NMB CONNECTOR WATER AND SEWER RELOCATIONS

(S.C. 90 AND S.C. 31 INTERCHANGE)
WATER PROJ. #496-01 /SEWER PROJ. #987-01

THESE DRAWINGS REFLECT
AS-BUILT
CONDITIONS

41-011-008

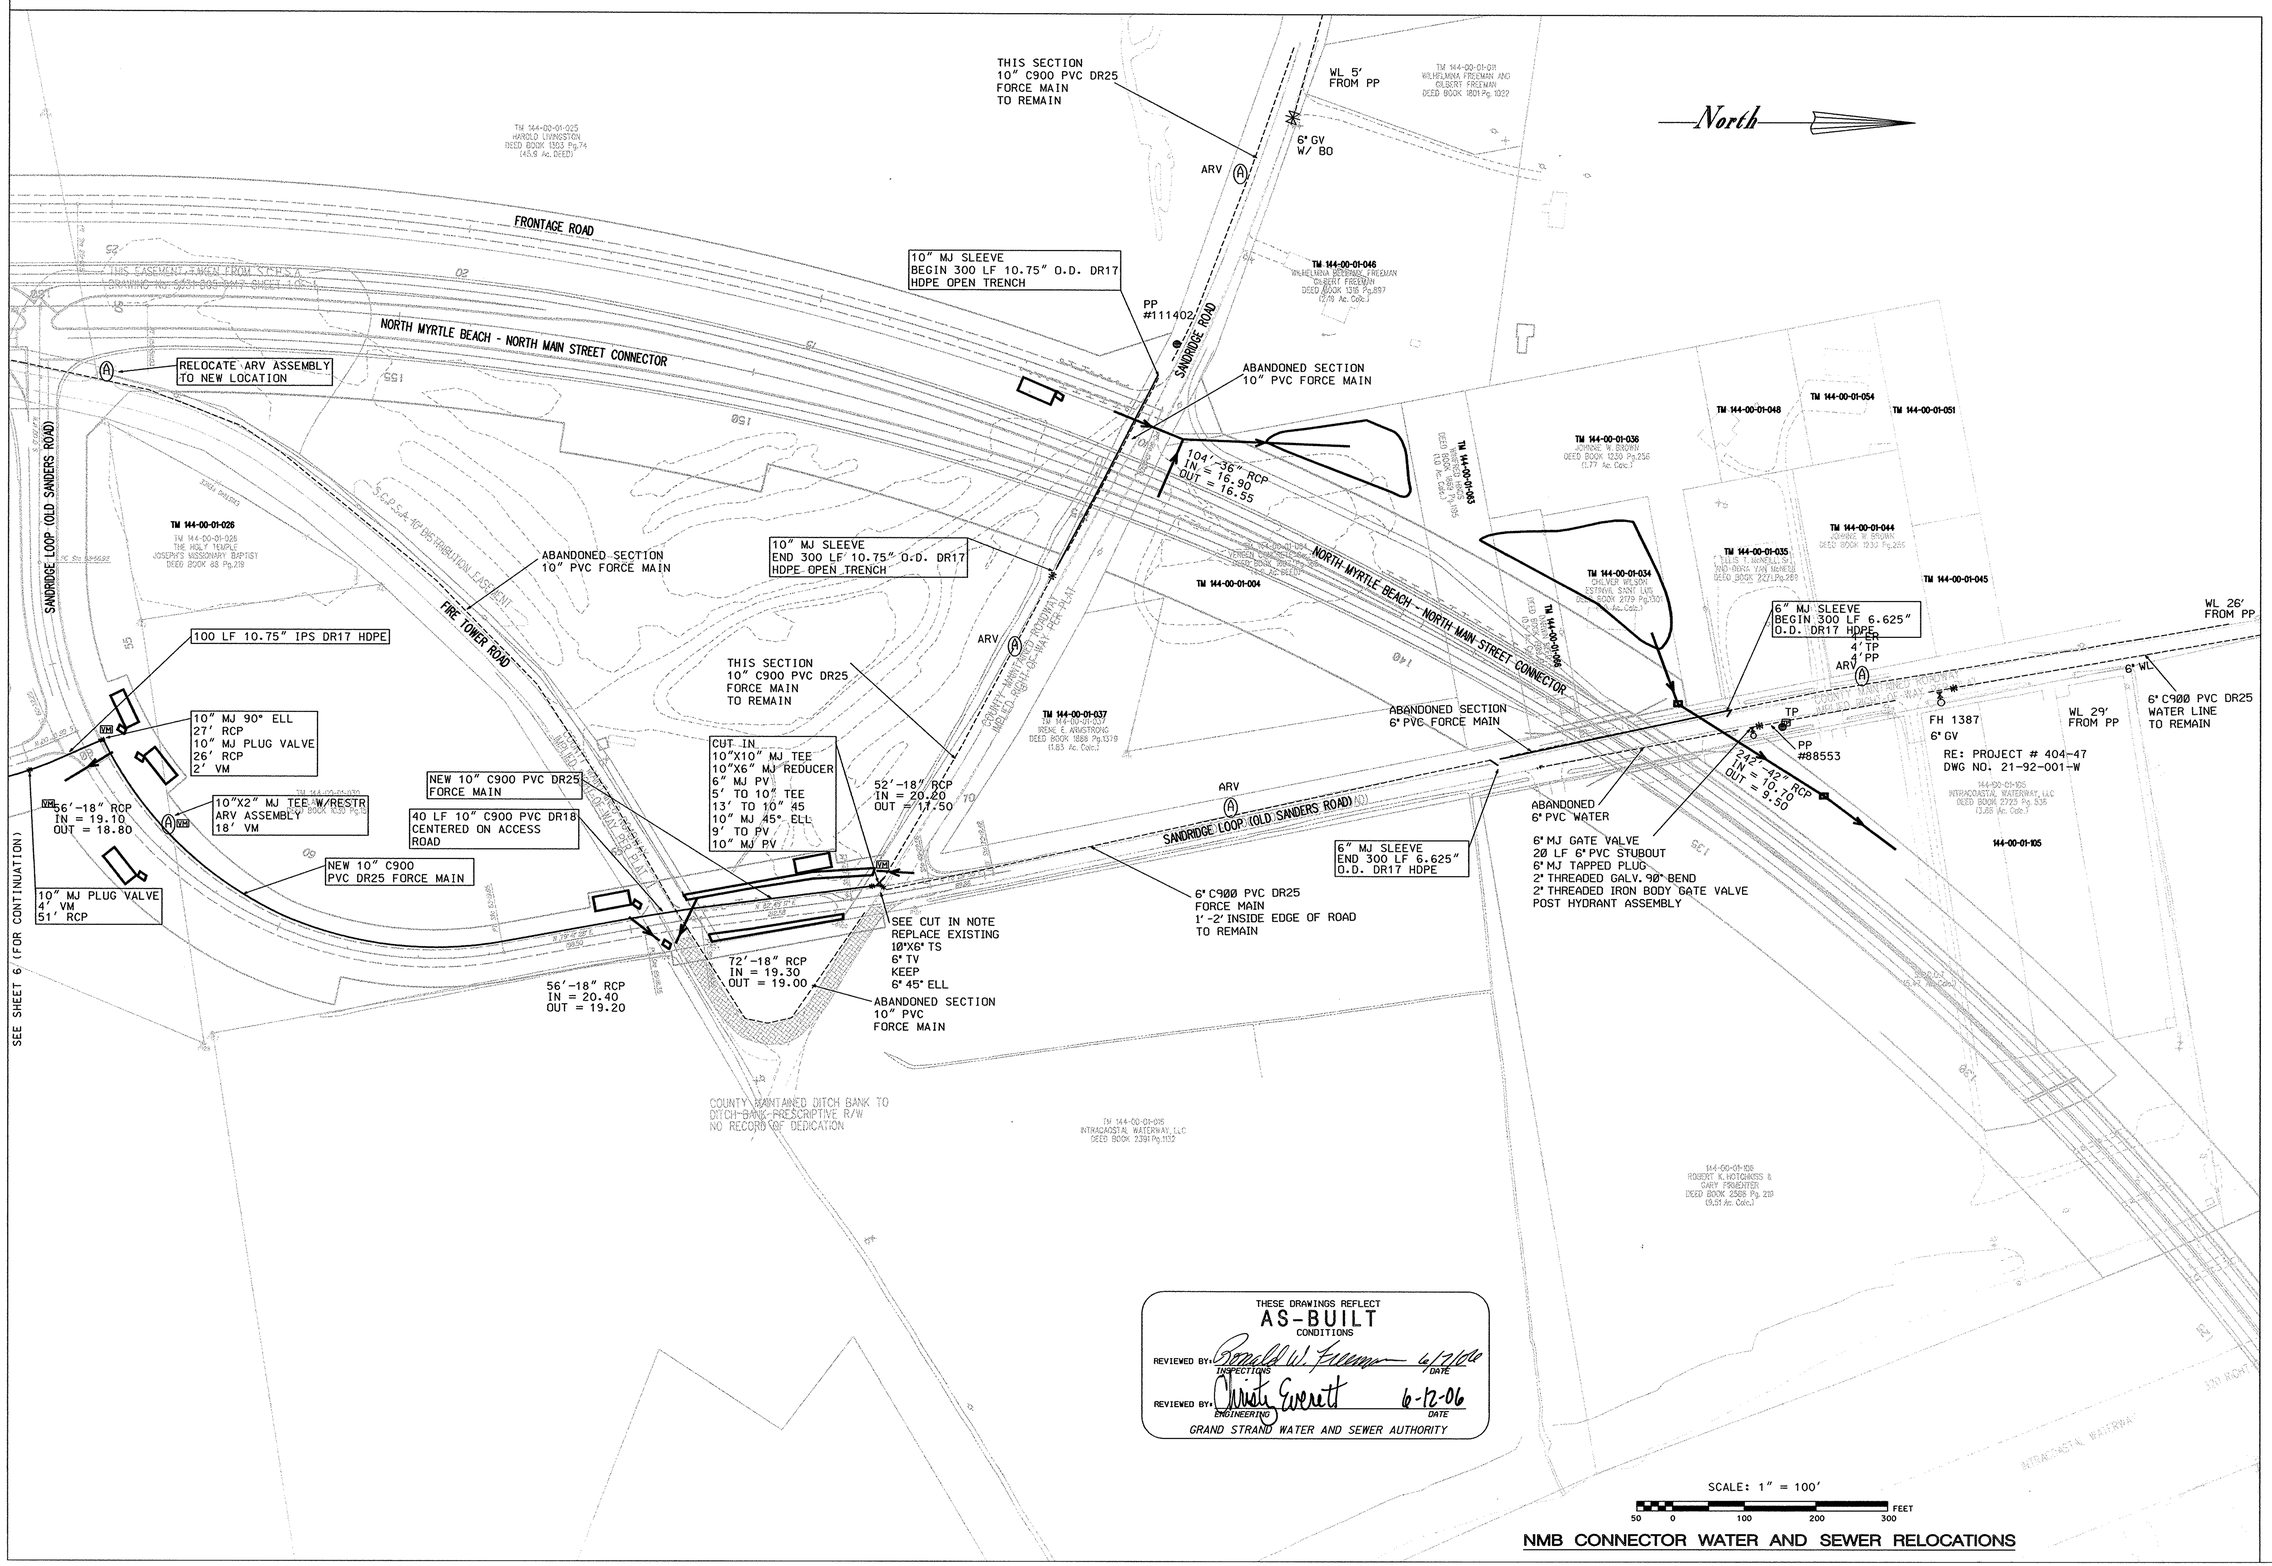
New FM installed
5' from old forcemain
on the North Side.
Old FM was removed

Install:
Two 10" MJ 45° Bends
angled to achieve separation
from Ex. 10" Fm
Did not need 45°
to tie together

Lower Existing 10" Fm within
Existing 15' wide Easement
(2' minimum Cover)
Approximately 520 LF

Install:
Two 10" MJ 45°
Bends angled
to achieve
separation from
Ex. 10" Fm

Exist.
Fm in
this area
to be
abandoned
